PROPOSED RESIDENTIAL DEVELOPMENT AT KINSEALY

Stage 1 Quality Audit

**(Incorporating a DMURS Street Design Audit, and Audits
of Accessibility, Cycling, Walking and Road Safety)**

CS CONSULTING

Figure 5.1 – Visibility Splay at development access

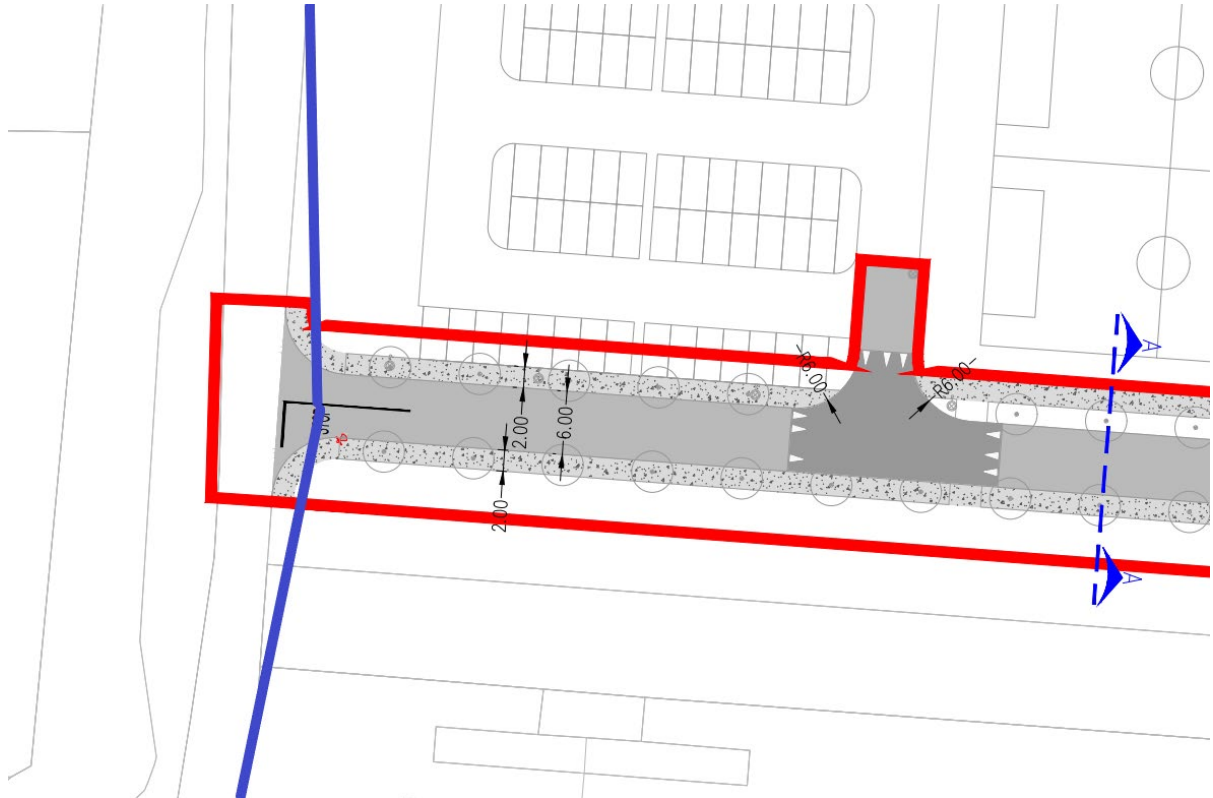
Visibility splays at the proposed development access from the R107 may be restricted by the existing roadside boundary either side of the access. A lack of adequate visibility splays may contribute to a turning collision at this location.

Ensure that adequate visibility splays are provided at the proposed development access.

Figure 5.2 – Visibility Splay not shown

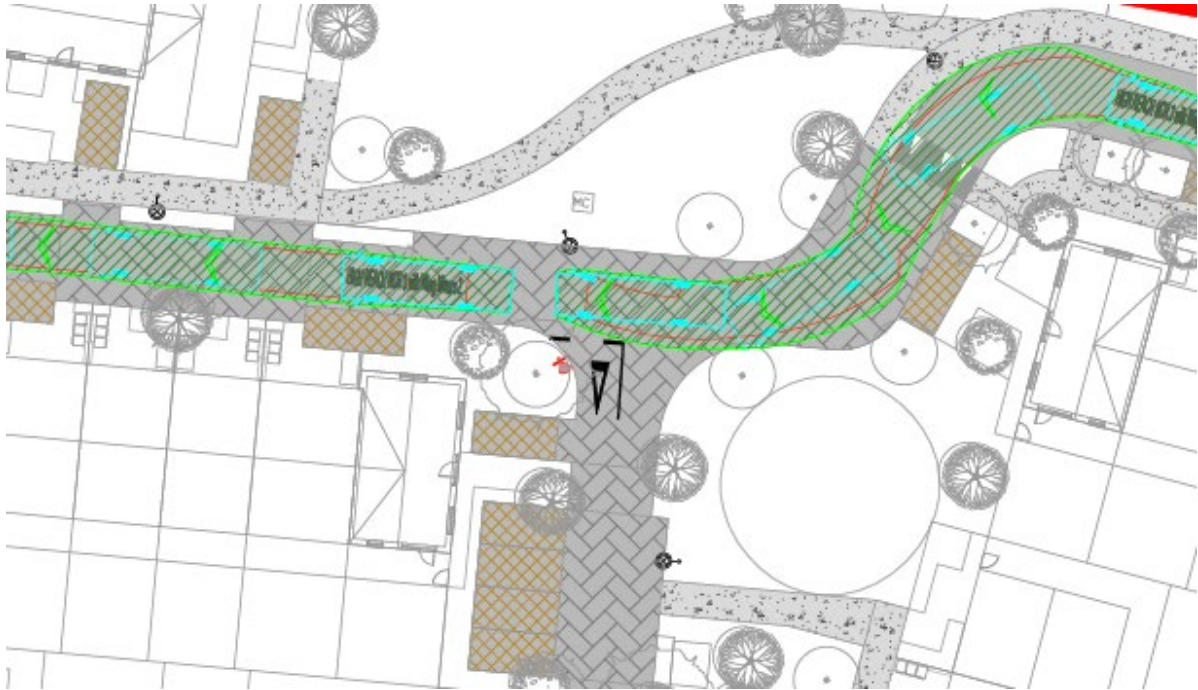
The visibility splay at various proposed junctions in the development, including but not limited to the one in Figure 5.2, will be compromised by proposed parking, planting, bin storage areas and internal boundaries. This may compromise vehicle-to-vehicle intervisibility, increasing the risk of collisions.

Ensure adequate visibility splays at all junctions. Revise parking and planting arrangements as necessary.

Figure 5.3 – Narrow Carraigeway

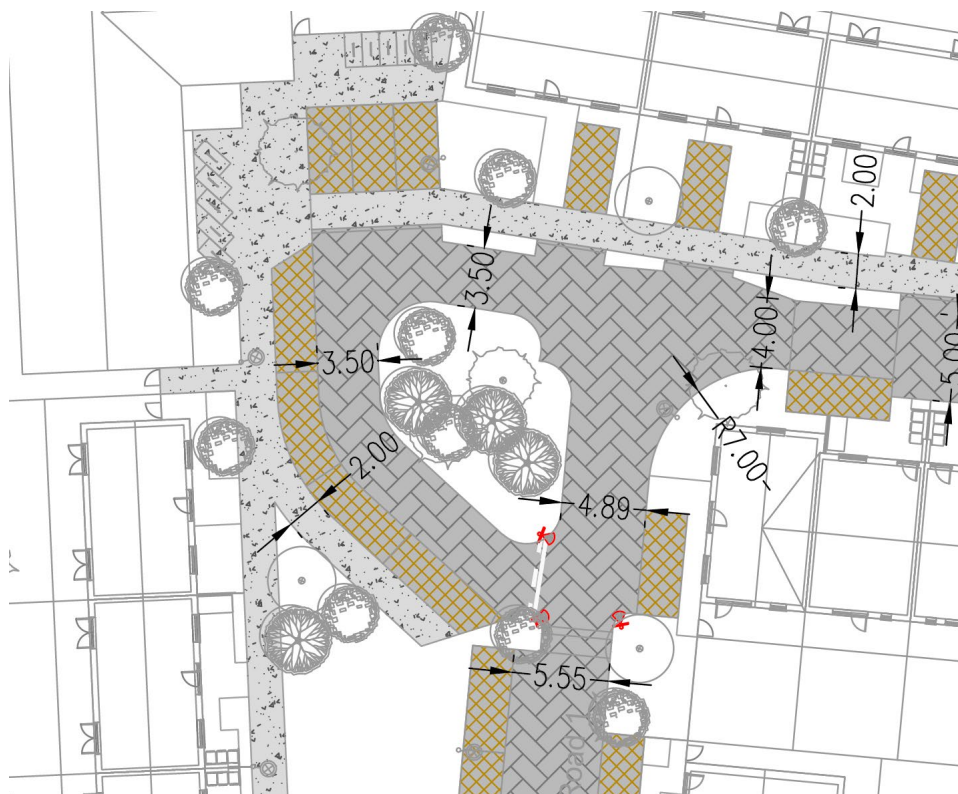
It is unclear how fire tender and refuse truck movements can occur in certain areas of the development (e.g. Figure 5.3). Tight manoeuvring spaces create a risk of kerb mounting with pedestrian injuries or colliding with parked vehicles. Parked vehicles in this area, on a bend, may also reduce the effective width of the carriageway further.

Ensure adequate swept path analyses for all vehicles. Consider minimum carraigeway widths as per DMURS and Building Regulations Part M.

Figure 5.4 – Raised carraigeways

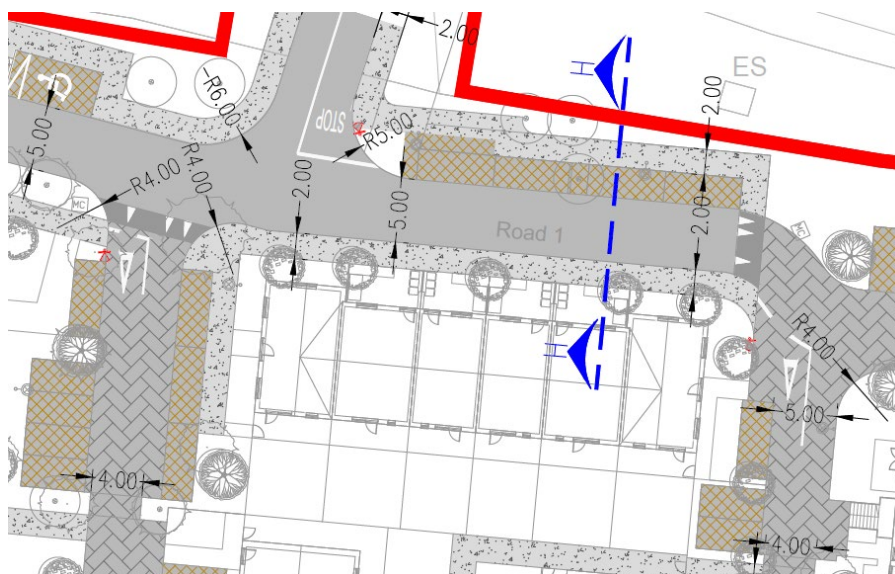
Various raised kerbs and vertical carraigeway deflections are proposed. It is unclear what the proposed drainage arrangements are at these locations. This may result in ponding of water and silting which may create a slipping risk for cyclists.

Ensure adequate drainage throughout the development.

Figure 5.5 – Compromised Stopping Sight Distances

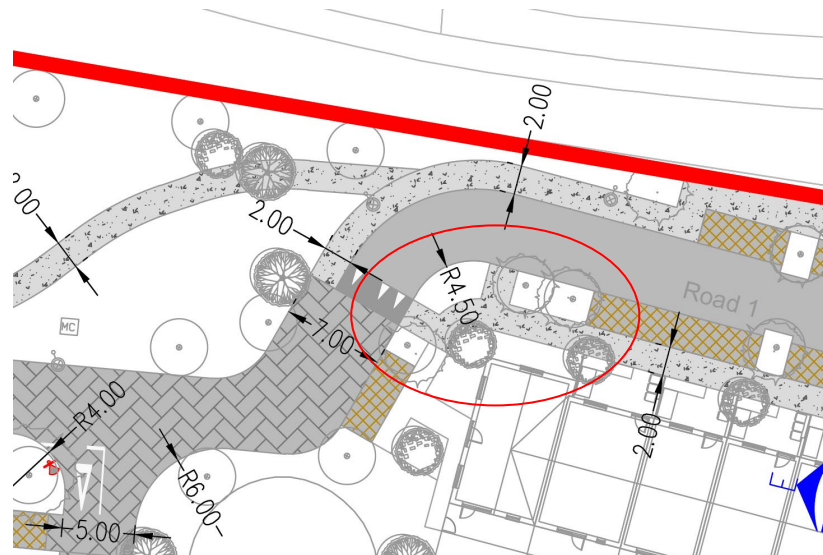
In some carriageway areas, the stopping sight distance (at corners) may be compromised by parked vehicles and proposed trees/planting. This may increase the risk of rear shunt, head on vehicles collisions or collisions with pedestrians within the shared space.

Ensure adequate stopping sight distances for all movements. Remove parking and trees as appropriate.

Figure 5.6 – Swept Path Analyses

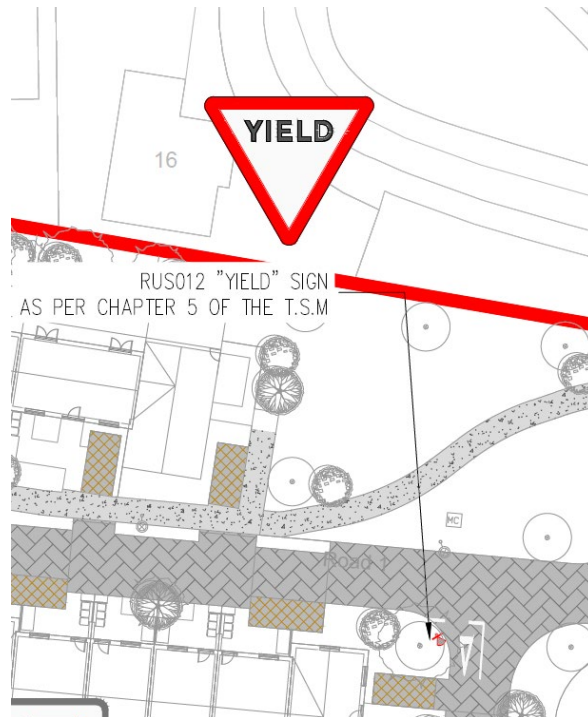
Some proposed road signs may be obscured by proposed trees, result in vehicle collisions.

Ensure all signage is separated from trees.

Figure 6.1 – Incomplete pedestrian desire lines

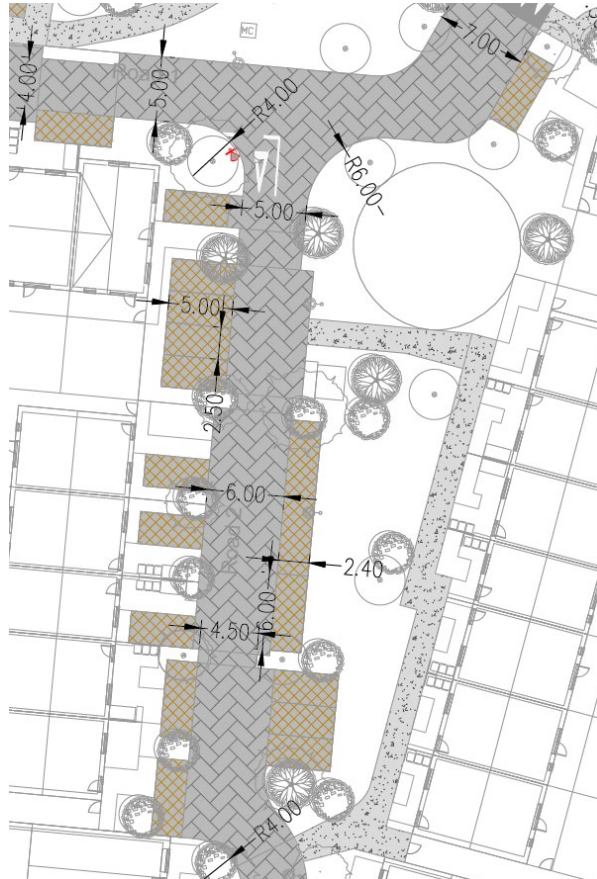
Not all pedestrian desire lines in the development are considered and some crossings are incomplete (i.e. parking on one side). This will reduce the attractiveness of walking in the development. It is also unclear how pedestrians will access the doors of certain properties.

Ensure adequate pedestrian infrastructure for all movements. Ensure all pedestrian crossings are complete.

5.8	Yes	Yes	-----	-----
5.9	Yes	Yes	-----	-----
5.10	Yes	Yes	-----	-----
6.1	No	No	The locations indicated are not pedestrian crossings but are transitions between footpaths and shared surfaces. Tactile paving and dropped kerbs (as appropriate) will be provided to make this clearer to users.	Yes

Figure 6.2 – Reduced Intervisibility between pedestrians and motorists

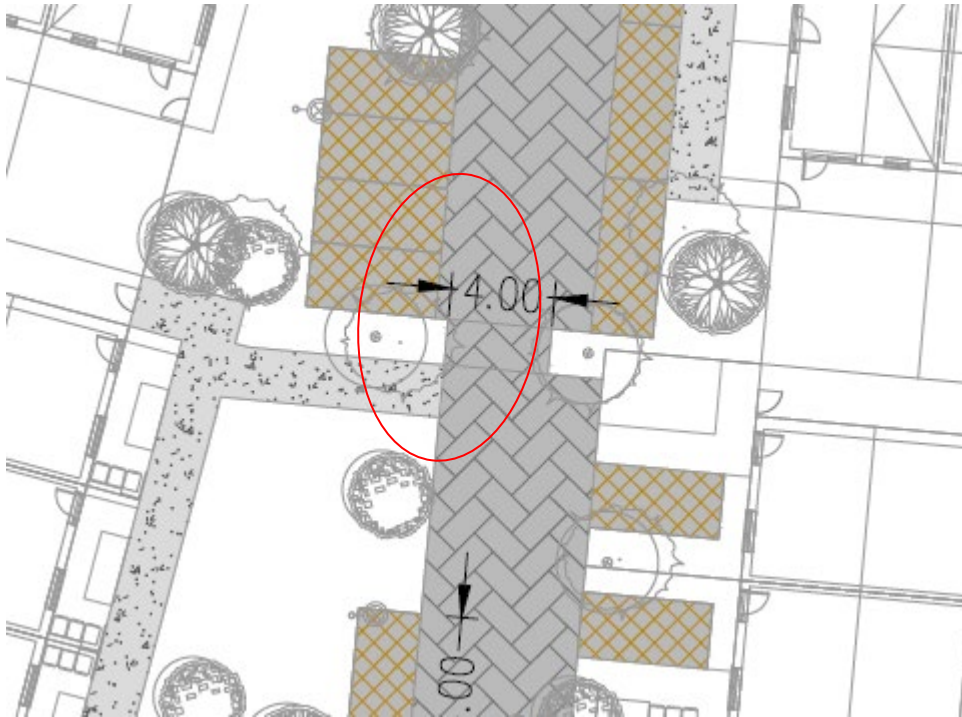
Pedestrian tie-ins at certain locations will be compromised by parked vehicles and trees (e.g. Figure 6.2). This will compromise intervisibility between pedestrians and motorists, potentially conflict and injuries.

Ensure adequate intervisibility between pedestrians and motorists at all locations.

Figure 6.3 – Footpath Alignment

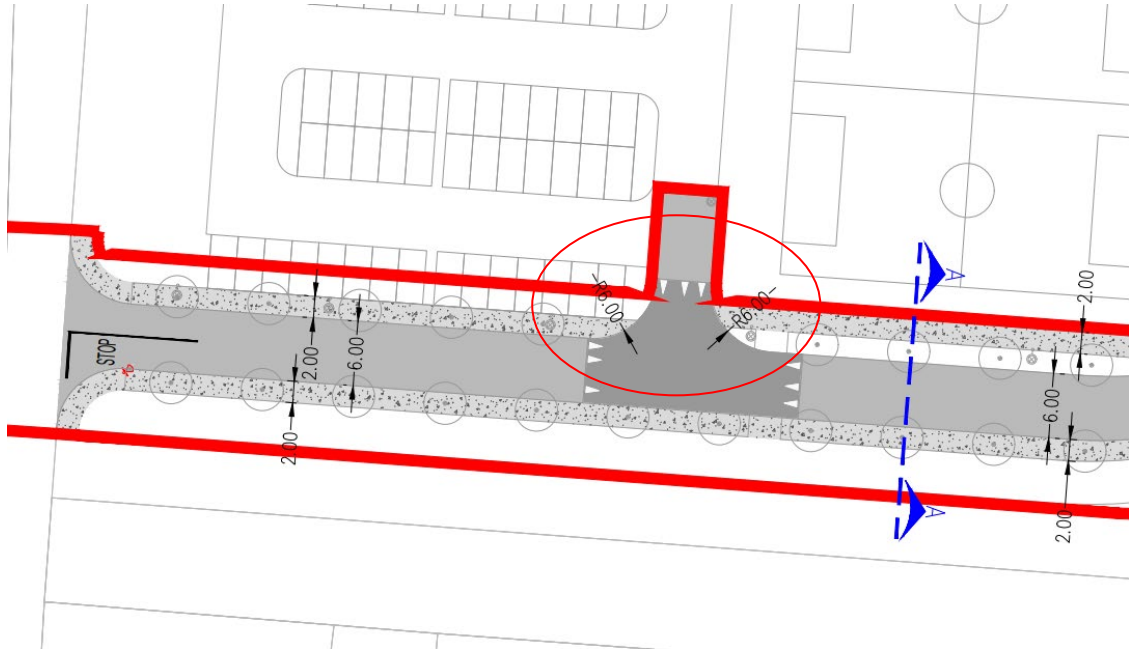
The proposed footpath alignment either side of the school access does not align with one another. This may lead to difficulties for visually impaired pedestrians crossing at this location.

Revise the footpath layout at this location so that the footpaths either side of the junction aligns with one another.

Figure 6.4 – Footpath Alignment

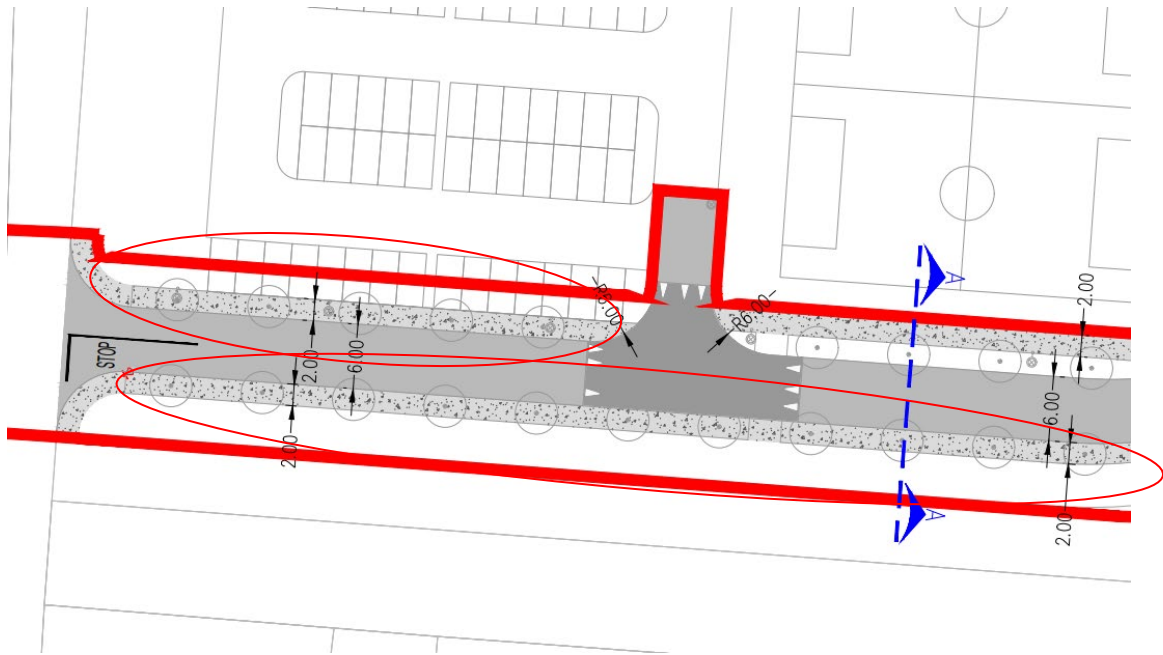
Trees are shown to be provided within footpath in a number of locations throughout the proposed development (e.g. Figure 6.4). trees and street furniture located within footpaths reduces its effective width and as a result pedestrians may be forced to travel along the carriageway where they would be at an increased risk of being struck by a passing vehicle.

Ensure trees and other street furniture do not reduce the effective width of footpaths within the proposed development.

Figure 6.5 – Pedestrian Access

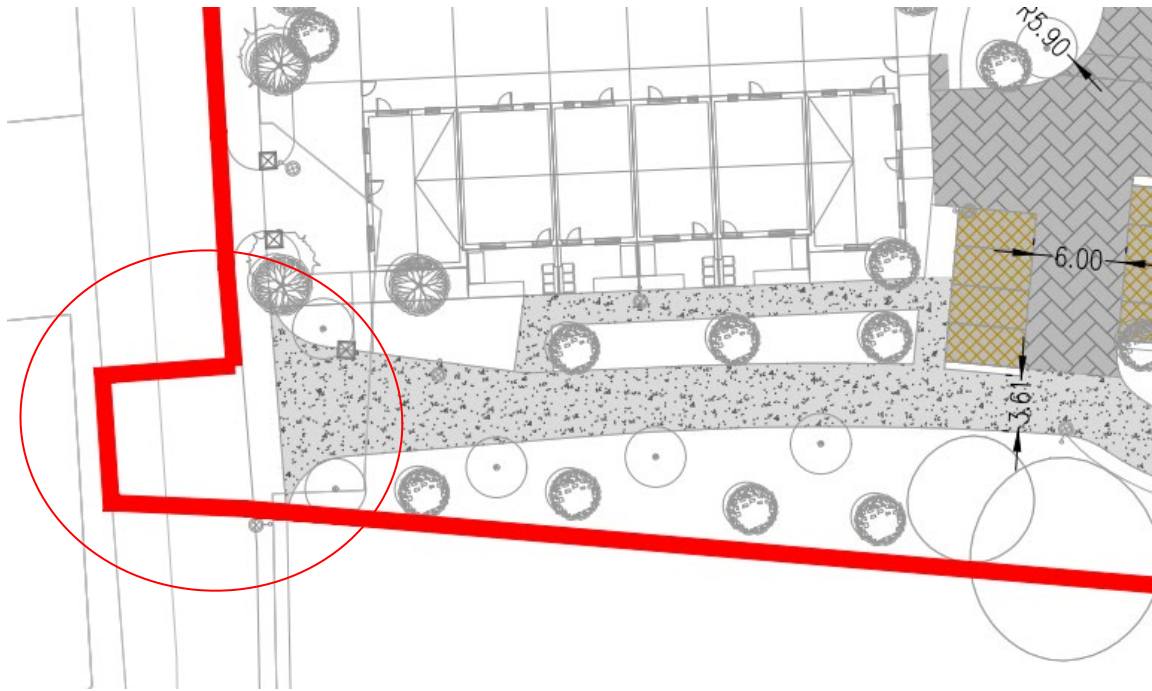
A pedestrian access is proposed from the development onto the R107. While there is a bus stop on the east side of the R107 at the proposed pedestrian access, there is no existing footpath on this side of the carriageway. This may result in pedestrians travelling along the carriageway or crossing the carriageway at an unsafe location.

Provide a suitable pedestrian crossing at the proposed pedestrian access to cater for pedestrians crossing the R107 at this location.

Figure 8.2 – Access to disabled parking

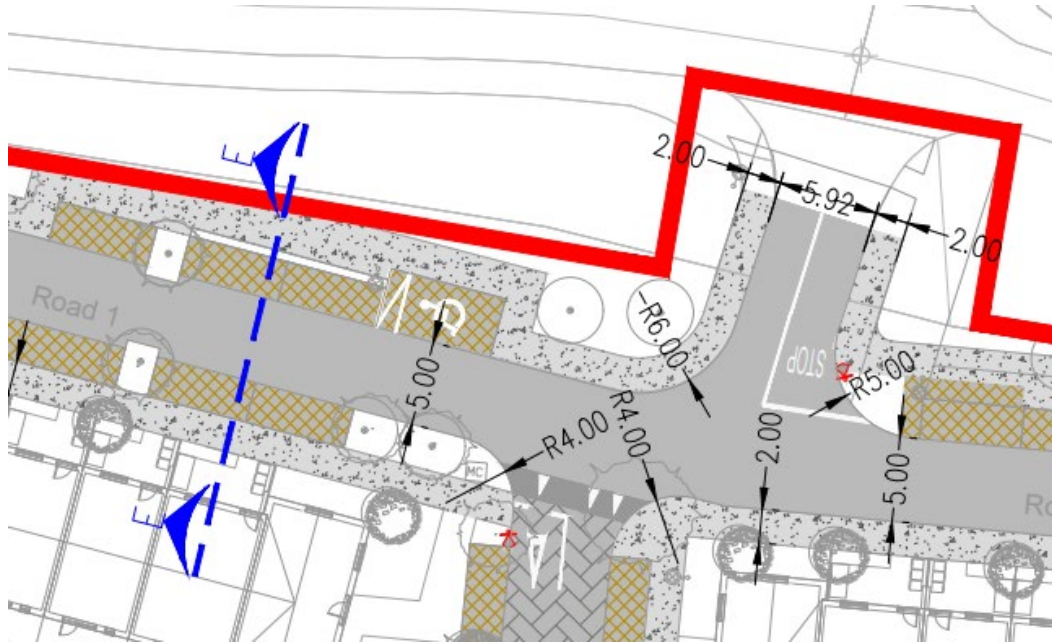
It is unclear if suitable access will be proposed from disabled parking spaces to the adjacent footpaths (e.g. Figure 8.2). A lack of appropriate dropped kerbs may lead to mobility impaired pedestrians travelling along the carriageway to access the footpaths increasing their risk of being struck by a passing vehicle.

Provide a dropped kerb at all locations where disabled parking spaces are provide adjacent to footpaths.
